Access Compliance Report
Public Rights-of-Way
(Pedestrian Signals)

ADA ID: E9C698C3E69C **Signal Type:** One Push Button-Non APS **Overall Compliance:** No **Severity Score:** BTN 1:N/A BTN 2: N/A **No BTN:** N/A

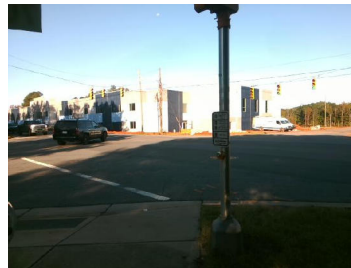
Surveyor Notes: NO SOUND FROM BUTTON

PROW/ADA: TMUTCD 4e.08, R404.2

Possible Solutions: Replace Signal Push Button With APS Button on New Post. Remove & Relocate Sign.
